OBJECTION TO PLANNING APPLICATION 2026/0477 from POSITIVELY HERSHAM, a sub- committee of HERSHAM COMMUNITY GROUP

This is an objection against Planning Application 2026/0477 regarding land to the South of 131 to 147 Burwood Road Hersham. This objection is one of several objections , sent under separate cover.

This particular objection is in relation to PROPOSED FOOTWAY along the south of Burwood Road

The Applicants have acknowledged that pedestrian access and egress to the site requires substantial works on land that is currently soft verge, bordering on a deep open ditch which serves as a main surface water sewer. The full extent of the work is referenced in the application plan Site Access and Footway Connection, number BWR-RGP-XX-XX-DR-T-002.

Detail of highway and ditch adjoining proposed development (to scale)

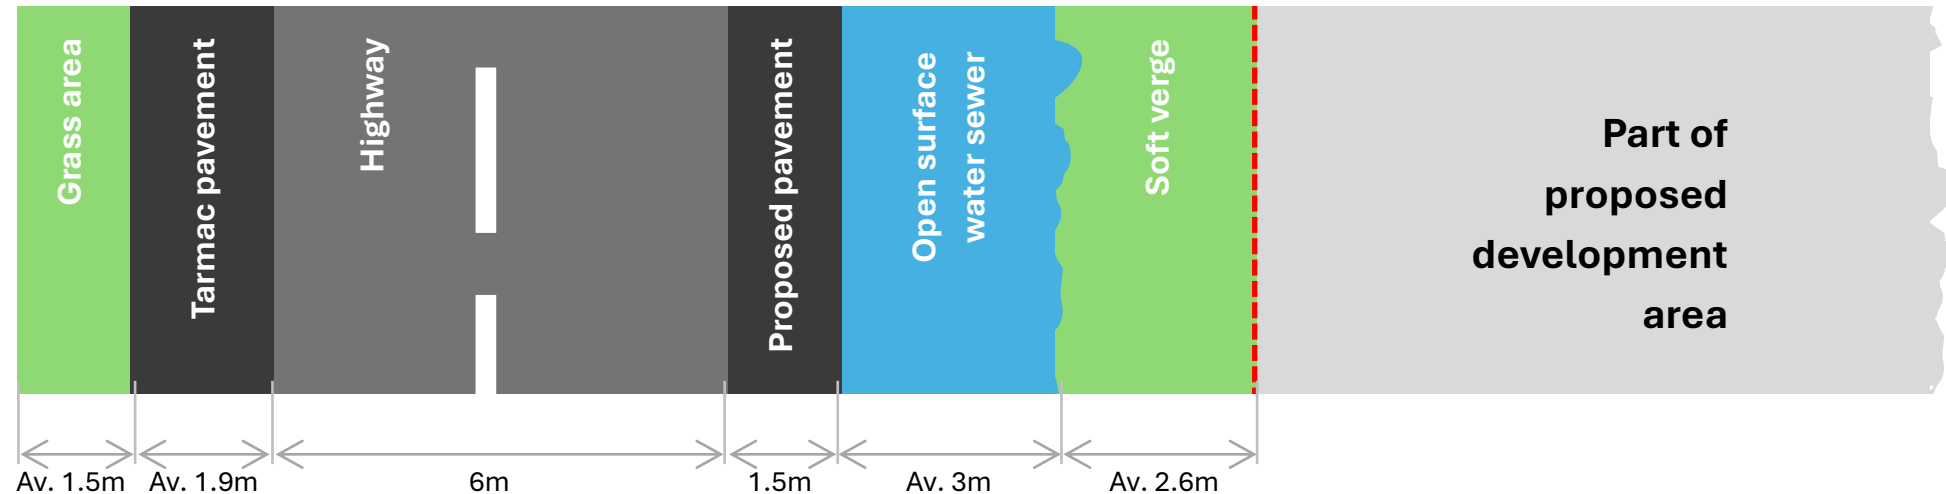
Whilst it is acknowledged that the Site Access plan is a proposal, it is also true to say that any proposal must consider the topography of the land in question and in this case there is no proposal to alter the course of the ditch in any way.

It is a fact that the distance from the road kerb to the edge of the ditch varies between 1.3m and 1.5m across very soft verge **see photo 3**. In order to achieve a pedestrian walkway of 1.5m (as suggested by the applicants) including a retaining wall to support the path, it will be necessary to undertake very substantial solid engineering works within a large part of the ditch, to the permanent detriment of the prime purpose of the ditch itself. The ditch is part of a SCC-Mapped Historic Wetspot.

The boundaries shown on the plans are inaccurate. The Highway Boundary is shown as being in the middle of the ditch but we believe that the boundary is the kerb on Burwood Road. The applicant boundary is also shown as being in the middle of the ditch. It is not, as evidenced by Land Registry. We believe the boundary of the applicant owned land is approximately 7m from the road kerb. It would seem that the applicant is relying on consent from unknown third-party ownership but it is not possible for a planning permission to place conditions on unknown third parties.

Cross sections (to scale)

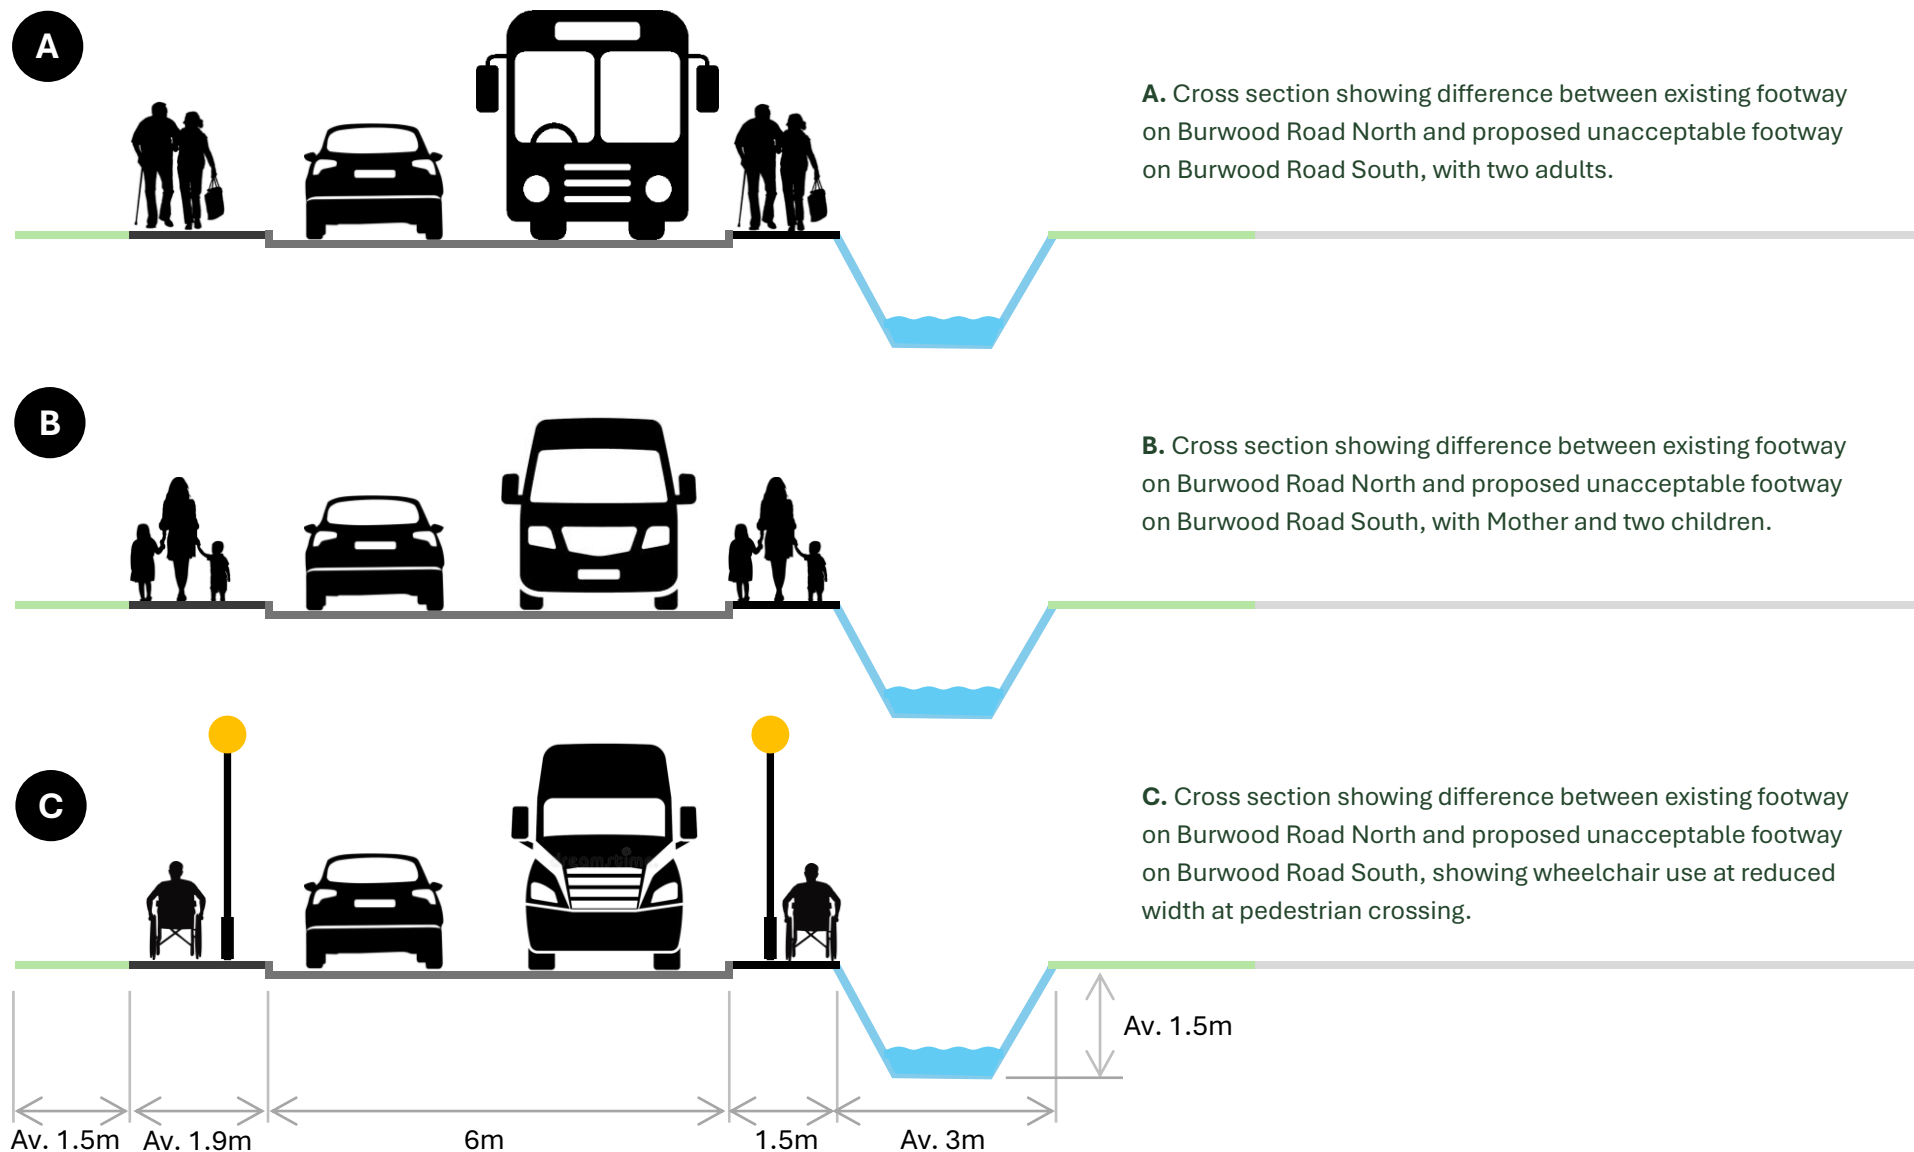
In addition, in view of the street furniture required for a pedestrian crossing and other lighting, the applicant shows on their plan that the width reduces to just 1.0m. With this in mind it is noted that the applicants have chosen to provide a Zebra crossing rather than a Controlled crossing which will require even more street furniture and create even more blockage to the free passage of pedestrians.

See cross section C.

This is an application for a new development on previously undeveloped land. At the very least it should comply with modern standards. It does not. The proposed new footway of 1.5m (even if it was possible to build), has an immediate unprotected drop into a deep open ditch. It, therefore, follows that the proposal gives rise to:

See cross sections A,B and C
